Tice River Homes

Legacy

model
36-02

project #
17052

page: **A1**

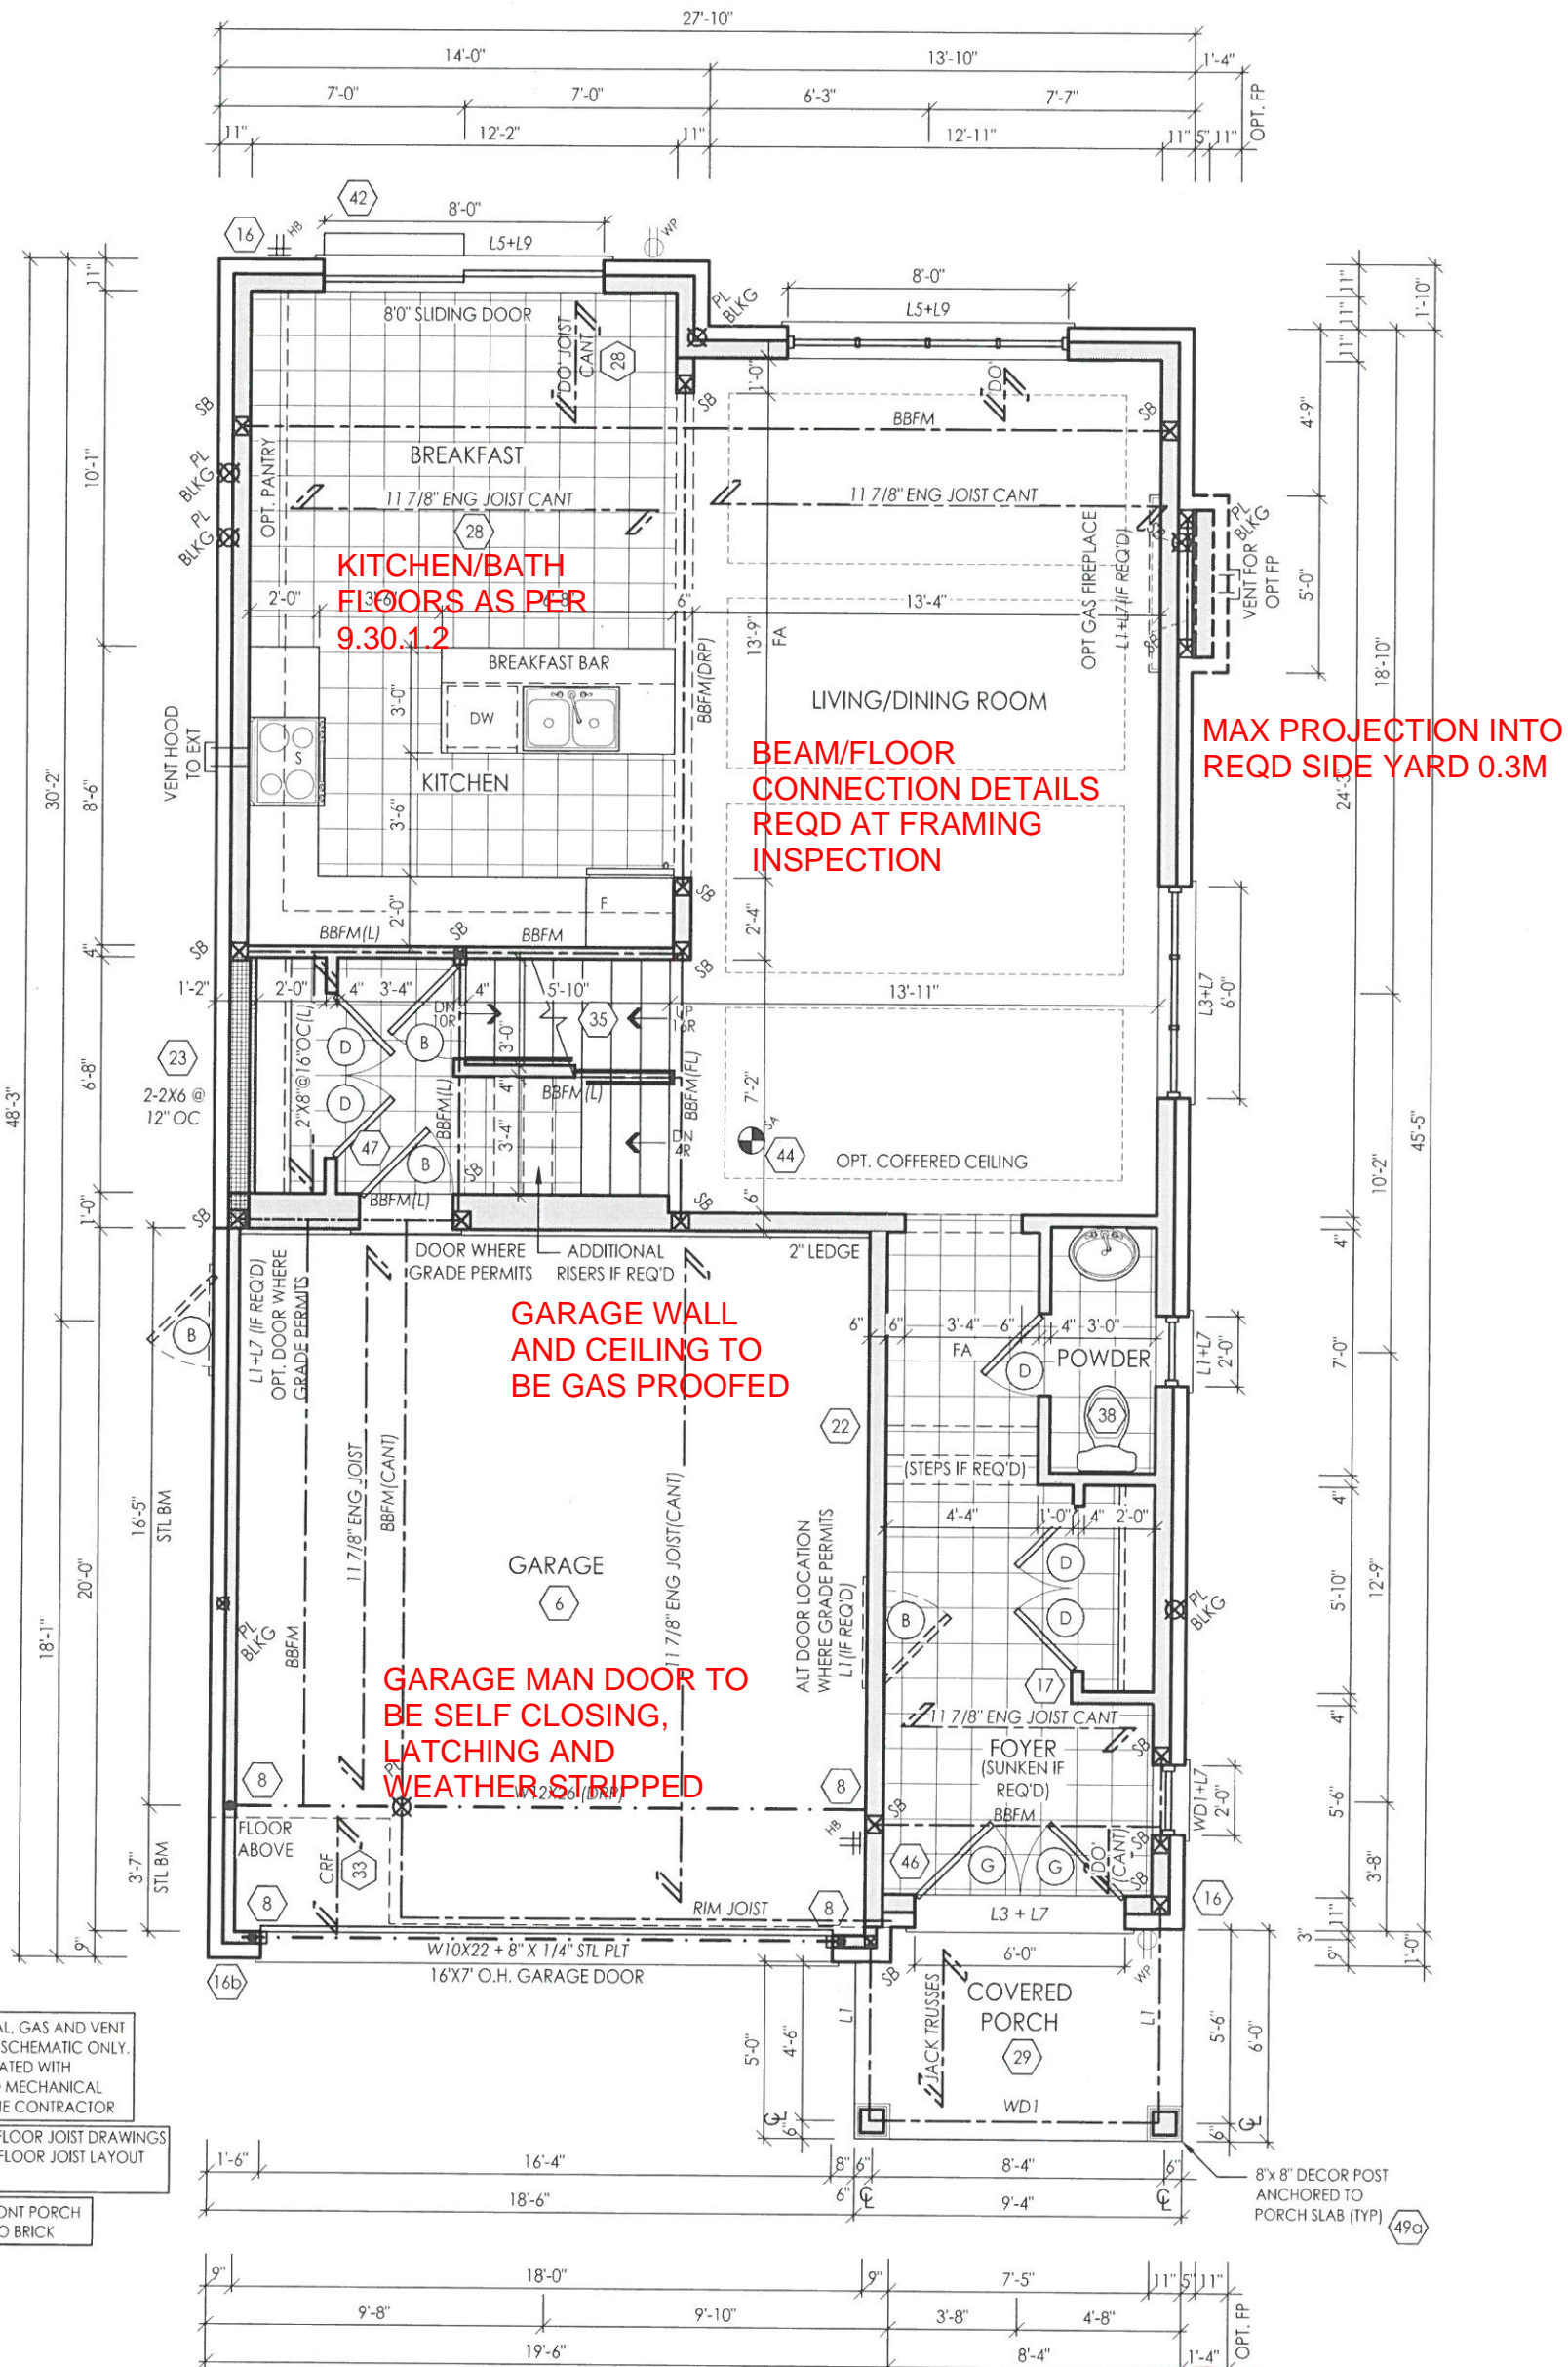
**BSMT AIR BARRIER
SUMP LIDS, JOINTS AT INTERSECTIONS
AND ALL PENETRATIONS OF SLAB MUST BE
SEALED TO PREVENT AIR LEAKAGE**

SECOND FLOOR ELEV. 'A'

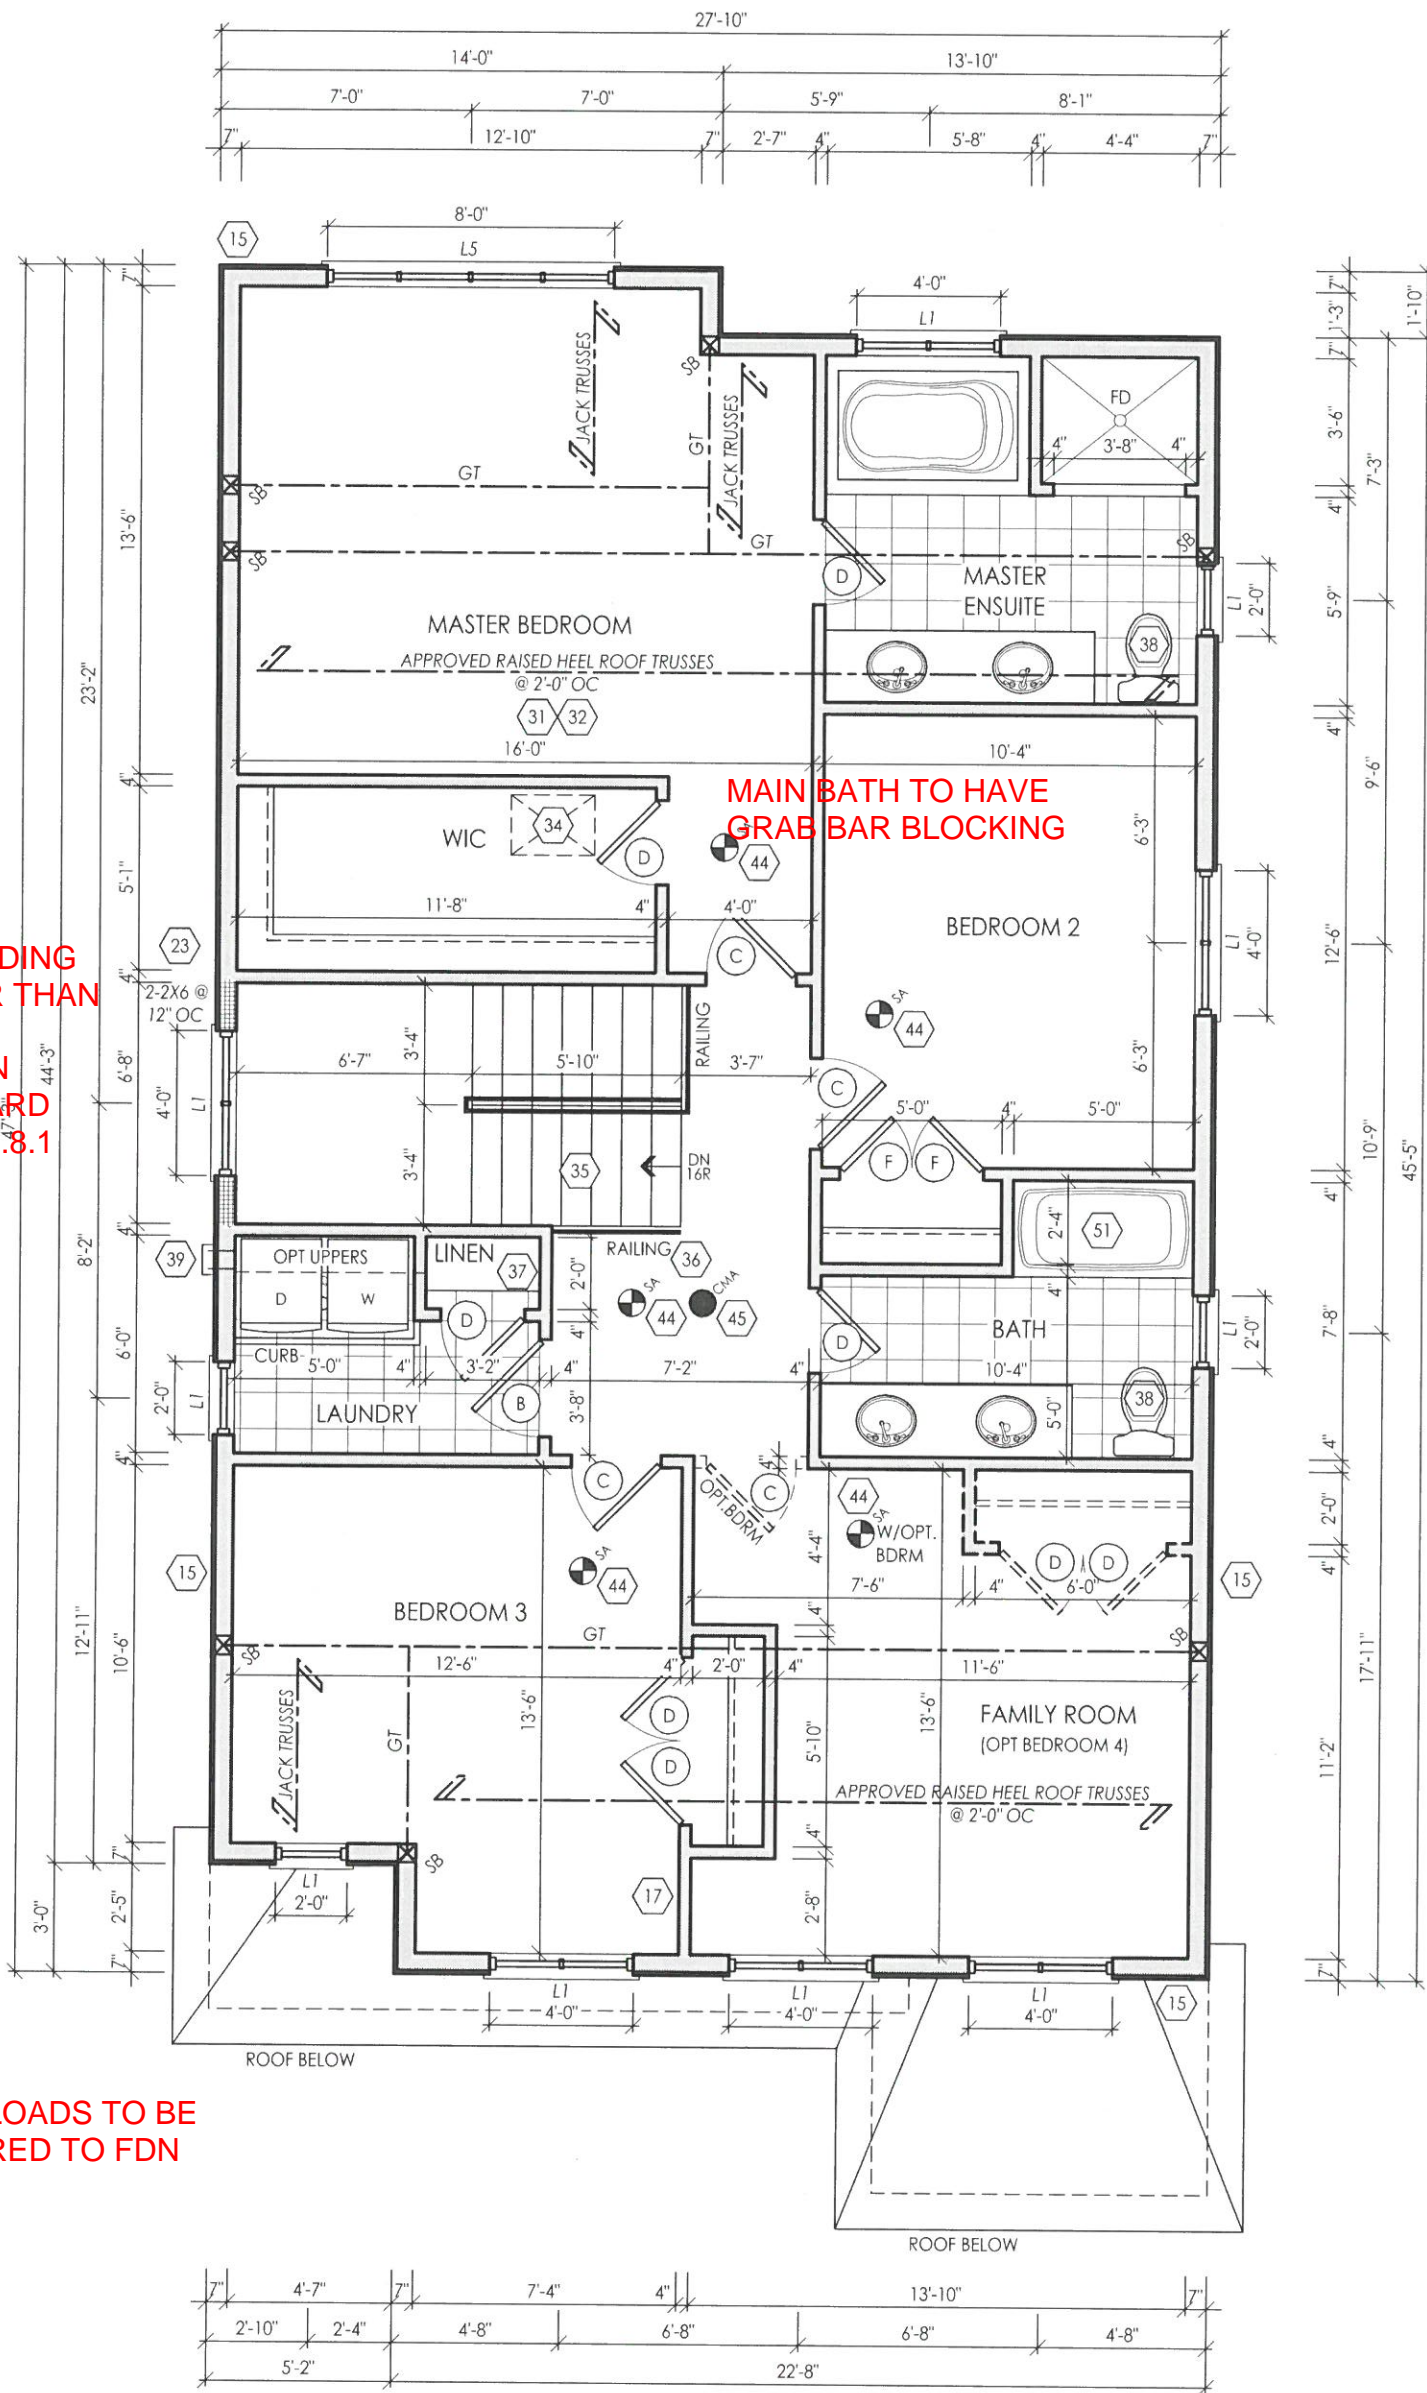
ENGINEERED FLOOR LAYOUT, TRUSSES AND LINTELS TO BE SUBMITTED PRIOR TO FRAMING. DESIGNER TO COMPLETE RESPONSIBILITY REVIEW FORM AND TO BE SUBMITTED WITH TRUSSES, FLOOR AND LINTEL DOCUMENTS

WINDOW ON LANDING MUST BE HIGHER THAN 3' ABOVE OR ENGINEERING ON WINDOW OR GUARD REQD AS PER 9.8.8.1

TALL WALL CONSTRUCTION

ALL POINT LOADS TO BE TRANSFERRED TO FDN
